**Project: IEEE P802.15 Working Group for Wireless Personal Area Networks (WPANs)**

**Submission Title:** [IL Comments Resolution]

**Abstract:** [This document proposed resolutions to comments on DF02]

Fig 155. Data field construction process

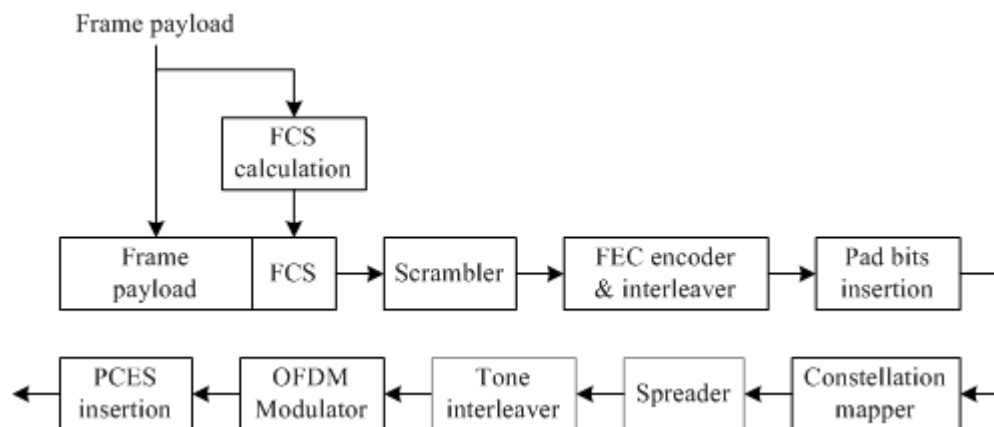
- **Comment 234, 238, 241, 243, 246,249,251,295** : Remove sub-clause 12.2.2.2.4 (Pad Bits) or remove from Table 106

- 12.3.2 Data field

The data field is the last component of the frame, and is constructed as shown in Figure 155.

- a) compute the FCS over frame payload,
- b) form the data field by appending the 4-octet FCS to the frame payload,
- c) scramble the resulting combination according to 12.3.2.2,
- d) encode the scrambled data field into NFEC codewords and interleave the result as specified in 12.3.2.3. The number of FEC codewords is calculated as follows:

- e) the resulting data field shall be concatenated with  $N_{PAD}$  pad bits in order to ensure that the resulting data field is aligned on the OFDM symbol boundary. The pad bits shall be set to zero and then scrambled using the continuation of the scrambler sequence that scrambled the frame payload and FCS in step a). The number of pad bits,  $N_{PAD}$ , shall be computed as follow. The number of encoded bits in the data field is given by:

- Remove Stuff chips subclause 12.2.2.2.4 and stuff chips from Table 106
- Remove pad bits 12.3.2.1 and pad bits from Table 129
- Same procedures should be applied to the headers in both SC and HSI-OFDM
